**Interactive comments on “Model study on potential contributions of the proposed Huangpu Gate to flood control in Taihu Lake basin”**

Zhang Hanghui, Liu Shuguang,  
Department of Hydraulic Engineering,  
Tongji University, 200092, Shanghai  
February 11, 2017  
zhang\_hanghui@hotmail.com  
RE: **hess-2016-310**

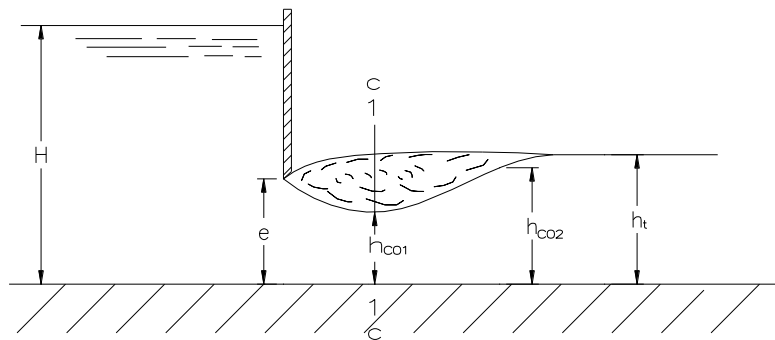
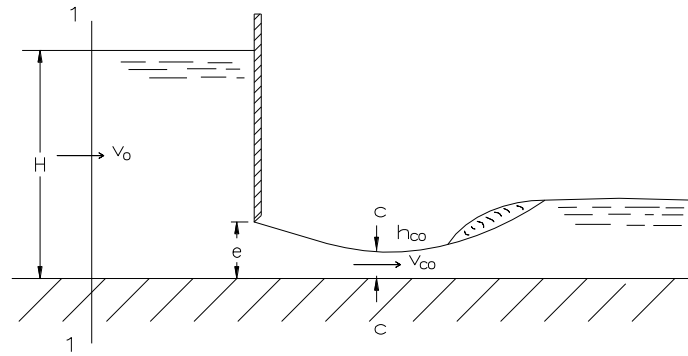
**Q(10)** Page 5 Line 3-4: please provide more details on how the water-engineering works are taken into account in the simulation.

*A: “Cheng et al. (2006)” is the main reference book which provides a lot of information about the HOHY model listed in the reference of our manuscript (Page 10 Line 35), more details can be found in Chapter 4 of this book. In addition, “Jin. (2008), page 53-55” also provides the details on the simulation of water-engineering works.*

*In the Taihu Basin, hydraulic structures are mainly weirs, sluice gates, and pump stations. Different structures have different governing equations. For example, simple explanations are as follows:*

*a) Broad-crested weir:*

*Free flow:*  $Q = \mu_e B \sqrt{2g(H_0 - h_t)}$

*Submerged flow:*  $Q = \phi_m B(Z_2 - Z_d) \sqrt{2g(Z_1 - Z_2)}$

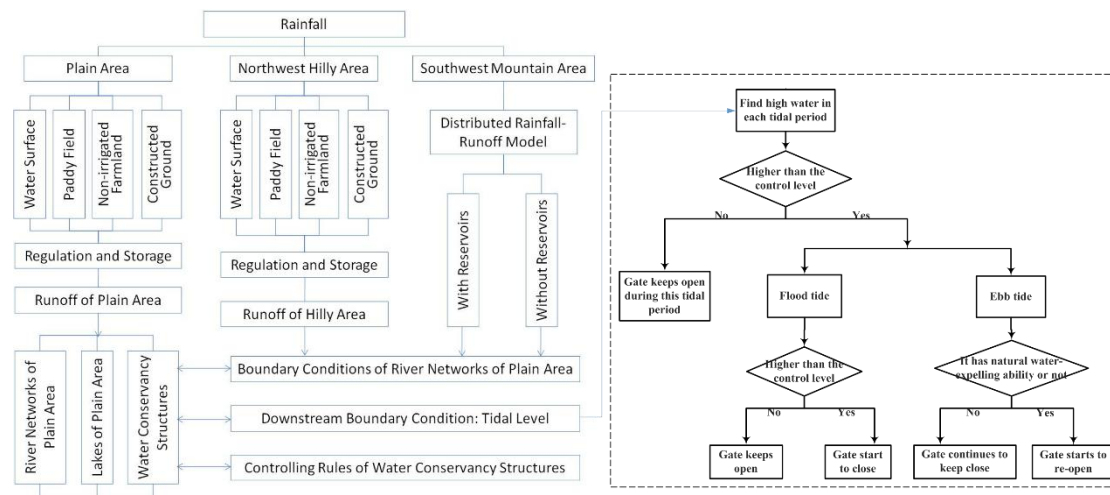
This manuscript tried to evaluate the potential contributions of the proposed Huangpu Gate to flood control in Taihu Lake basin using a hydraulic model under several flooding scenarios. The results show that the proposed gate is effective mean to evacuate the floodwaters. Maybe it is a useful demonstration of the project. However, the contribution to scientific progress is not clear, since the method of scenarios analysis is not new and the model is not new.

Although the model used in the paper is not completely new, we modified the model codes to accommodate additional capabilities for the more complex simulation. The Schematization of the modified model is shown in the figure with table gridlines as below. The model extension focuses on the flood routing part, related to the algorithms of unsteady open channel flow, and the inputs of control rules of the gates related to the tidal conditions. The main program was improved by adding a function to judge the stage of tide before running the gates (i.e. in flood or ebb tide), which makes the specification of the gate's control rules more flexible.
